# Access Compliance Report

## Public Rights-of-Way

### (Curb Ramps)

Intersection ID: N/A	Main Street: MONROE_RD	Cross Street: N/A	Location: SW
ADA ID: 2849F873BD67	Ramp Type: Directional1	Initial Pass/Fail: Fail	Overall Compliance: No
		Severity Score: 13.75

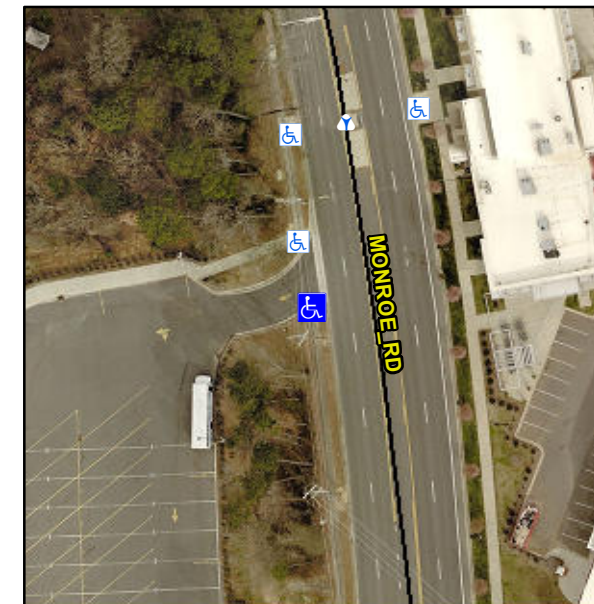
**DWS DETACHED/NAILS EXPOSED**

**R304.2.2**

Compliance	Description	Data	Compliance	Description	Data
N/A	Ramp Length (in)	89.0	N/A	Grade Break?	N/A
Yes	Ramp Width (in)	62.0	N/A	Grade Break Slope (%)	0.0
No	Ramp Slope (%)	11.1	N/A	Grade Break XSlope (%)	0.0
Yes	Ramp XSlope (%)	2.2			
N/A	Flare Type LT	N/A	N/A	Flare Type RT	N/A
N/A	Flare Slope LT (%)	N/A	N/A	Flare Slope RT (%)	0.0
N/A	Flare Traversable LT?	N/A	N/A	Flare Traversable RT?	N/A
N/A	Landing Length (in)	0.0	N/A	DWS Provided?	N/A
N/A	Landing Width (in)	0.0	N/A	DWS Contrast?	N/A
N/A	Landing Slope (%)	0.0	N/A	DWS Length (in)	N/A
N/A	Landing X Slope (%)	0.0	N/A	DWS Full Width?	N/A
N/A	Landing Curb? (Y/N)	N/A	N/A	DWS Offset LT (in)	N/A
N/A	Shared Landing?	N/A	N/A	DWS Offset RT (in)	N/A
N/A	Gutter Ponding?	0.0	N/A	Gutter Slope (%)	N/A
N/A	Gutter Lip Ht (in)	0.0	N/A	Gutter X Slope (%)	N/A
N/A	Painted X Walk1?	No		Road Slope (%)	2.8
	X Walk 1 Direction	To NW		Road X Slope (%)	2.6
	X Walk 1 Width (in)	N/A		Clear Space?	N/A

**Remove & Replace Entire Ramp.**
